BLAISE AD HAZOP

RMD-02-004

An interface HAZOP study was undertaken at BioConstruct's offices at Stockton-on-Tees, Teesside on 3rd June 2019, commencing on 4th June and being completed on 9th July, on the design of the proposed Anaerobic Digestion Facility for Crofthead.

This report details the findings of the HAZOP Study. The drawings used in the HAZOP study are found in the Drawings Section of this report and are based upon the following P&IDs:

Node 1 —

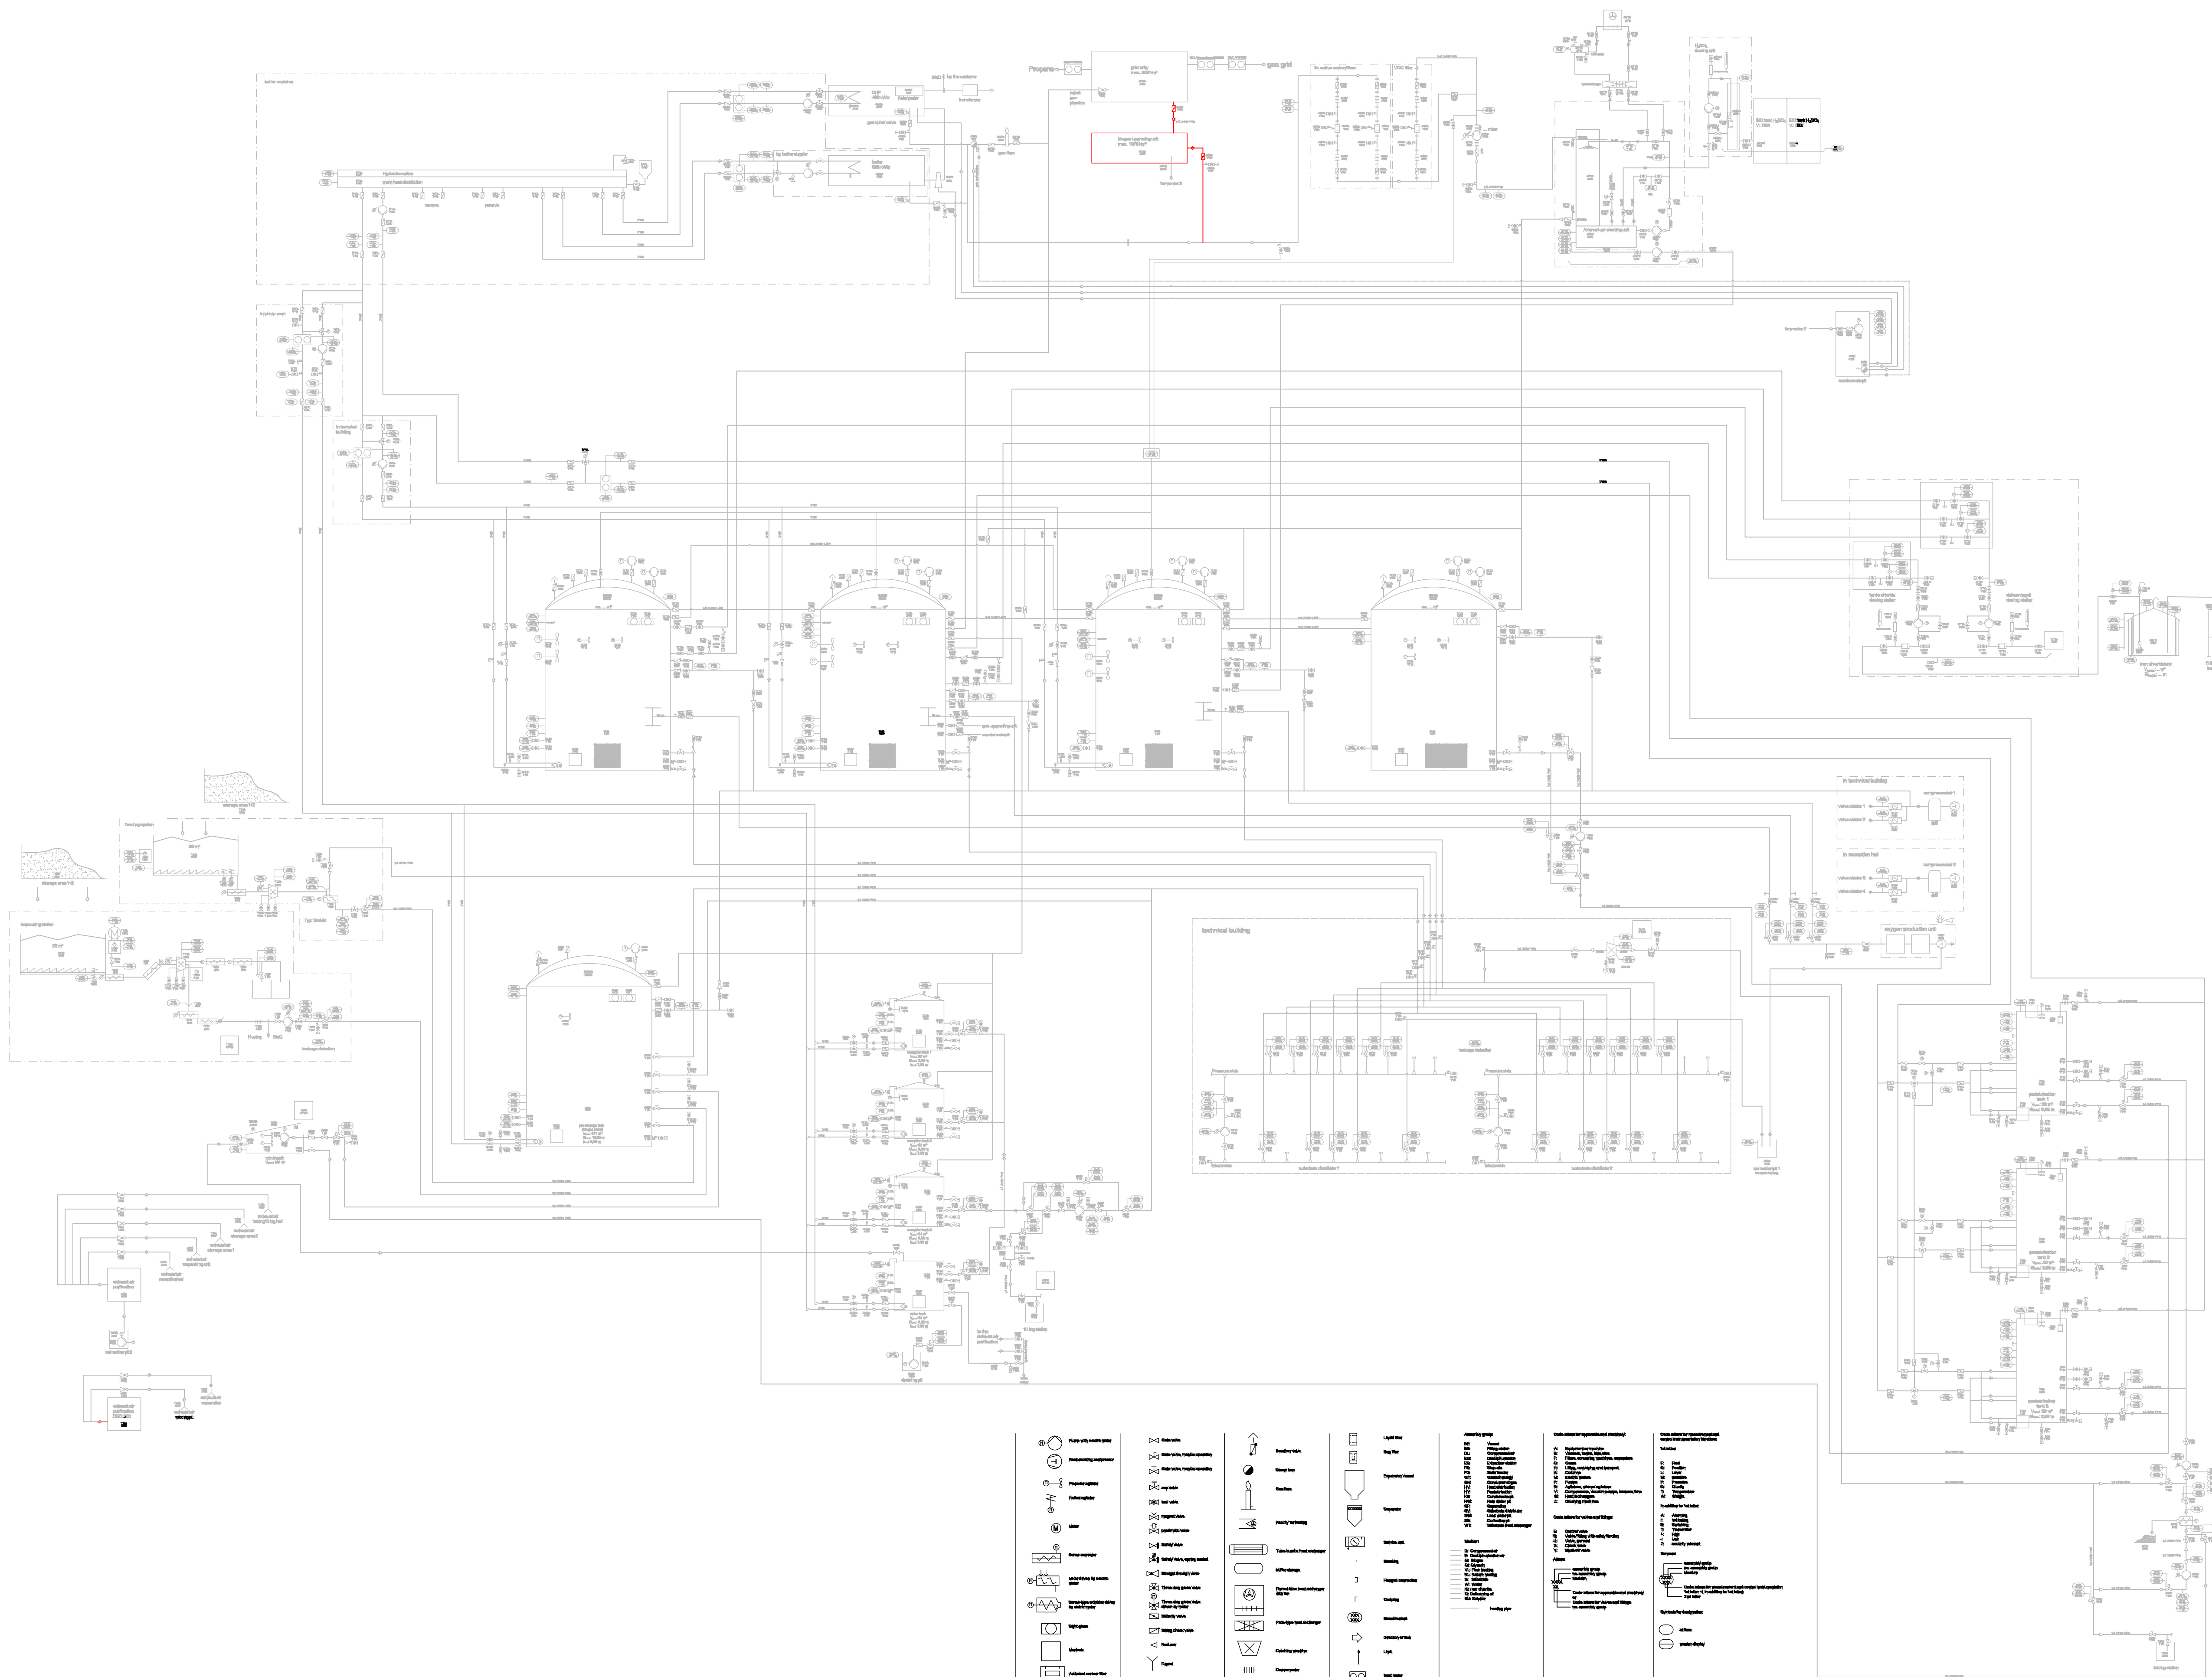
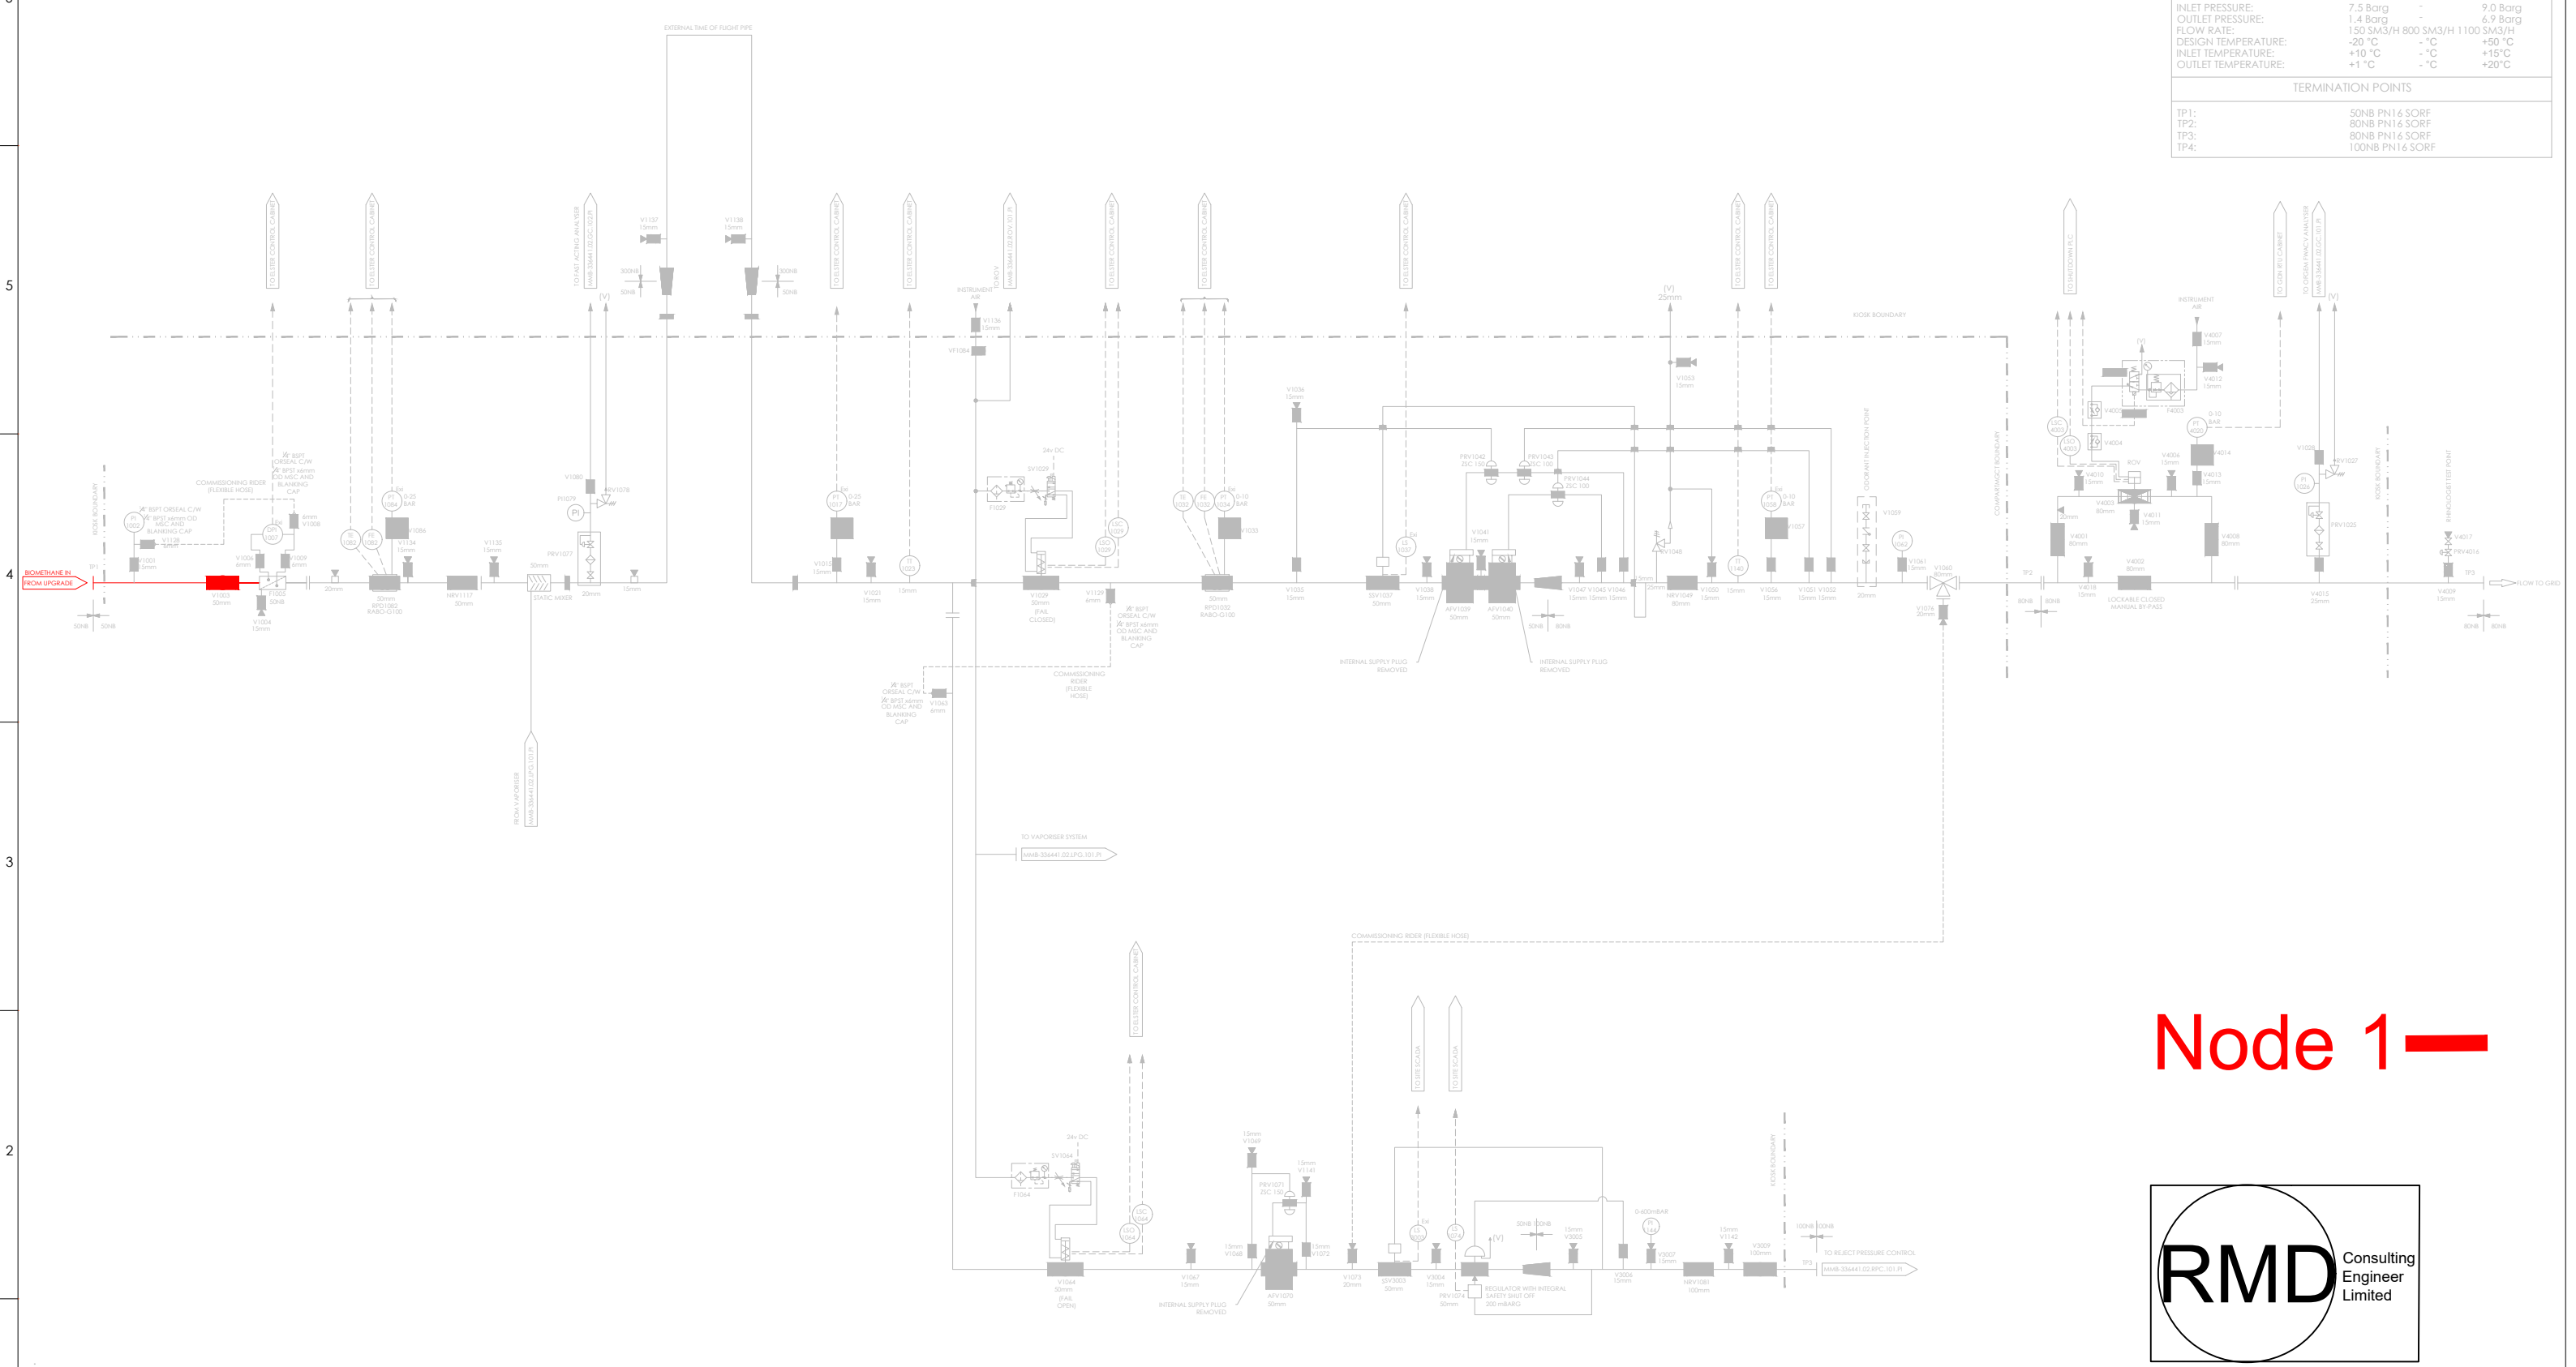
| ID/No. | Deviation | | No. | Possible Causes | Consequence | Safeguards | No. | Actions Required | Action Allocated to |
|--------|----------------|-----------|-------|--|--|--|---------|---|----------------------------|
| 1.1 | No | Flow | 1.1.1 | No flow into the BUU Poor biogas quality | <ul style="list-style-type: none"> Poor gas quality to Pentair unit potential for out of spec biomethane failure of GSMR specifications reject from GEU | <ul style="list-style-type: none"> Biogas analysis within AD facility will identify out of spec biogas feed to Pentair and will prevent feed to BUU - Pentair take BioConstruct signals and determine biogas quality Methane measurement within Pentair unit to ensure correct quality feed to GEU | | | |
| | | | 1.1.2 | Manual valve GT5G Y300 closed when should be open normally open operator / commissioning / maintenance error | <ul style="list-style-type: none"> Valve shut prior to start-up of Pentair unit results in low flow signal and inability to start the Pentair unit Valve closed during operation potential catastrophic failure of compressors increased fire and explosion risk | <ul style="list-style-type: none"> Operator training Pre-commissioning and post maintenance checks Secure site Low pressure alarm shuts down Pentair unit compressors Overpressure relief within Pentair unit through PSV-2802-01 (14barg) | | | |
| 1.2 | No | Flow | 1.2.1 | No flow to GEU | <ul style="list-style-type: none"> No flow of biomethane to the GEU - no injection to grid inefficient operation Potential overpressure of BUU, increased fire and explosion risk | <ul style="list-style-type: none"> Operator training Pre-commissioning and post maintenance checks Overpressure relief within the BUU Alarm signals from the BUU ROV will stay open Ability to interrogate the Pentair through the BioConstruct dial in system | | | |
| | | | 1.2.2 | Manual valve GT6G Y300 closed when should be open normally open operator / maintenance / commissioning error | | | | | |
| 1.4 | More | Pressure | 1.4.1 | High inlet pressure from BUU | <ul style="list-style-type: none"> Potential overpressure of GUU - increased fire and explosion risk | <ul style="list-style-type: none"> GEU pipework and system designed to 16 bar pressure Interconnecting pipework between BEU and GEU designed to 16 bar pressure Overpressure relief in BUU 14bar Pressure regulator PCV-2904-01 regulates inlet pressure to GEU to approximately 7.5 - 8.5barg | | | |
| 1.5 | No | Signal | 1.5.1 | Loss of signal from BUU to GEU | <ul style="list-style-type: none"> Loss of signal will result in shutdown of GEU if operational if not operational GEU sits in readiness | <ul style="list-style-type: none"> Reciprocal watch dog on signals which will alarm on loss of signal Shutdown of GEU will result in controlled shutdown of BEU | | | |
| | | | 1.5.2 | Loss of signal from GEU to BUU | <ul style="list-style-type: none"> Loss of signal will result in controlled shutdown of BEU resulting in controlled shutdown of GEU | <ul style="list-style-type: none"> Reciprocal watch dog on signals which will alarm on loss of signal Shutdown of BEU will result in controlled shutdown of GEU | | | |

| ID/No. | Deviation | | No. | Possible Causes | Consequence | Safeguards | No. | Actions Required | Action Allocated to |
|--------|----------------|-----------|-------|--|--|--|---------|---|----------------------------|
| 1.3 | General Action | | | | | | 1.3.2.1 | Ensure design of pipework between BUU and GUU is corrects | DNG, Elster & BioConstruct |
